October 17, 2013

Important Product Safety Bulletin **DSL, MDSL and NPL Type Limiter Fuses** **May not Interrupt Correctly under Fault Load**

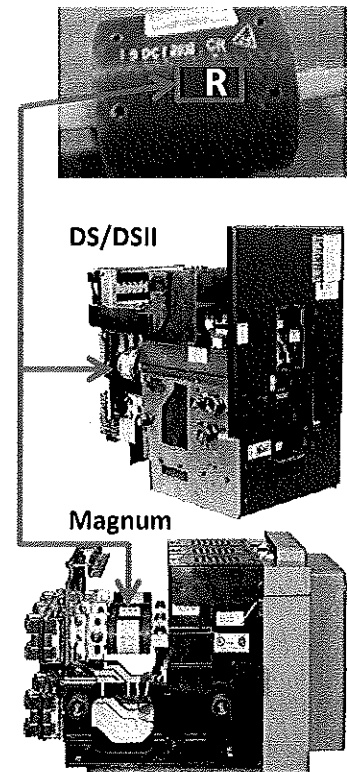
Confirm you have the subject product by visual inspection looking for the product catalog number and the date code found on the product label as shown in the sample picture top right. The date code stamp is located on the body of the limiter. Recertified units will have a white "R" stamp near the manufacturing date. These have been certified as fully functional and do not need to be replaced.
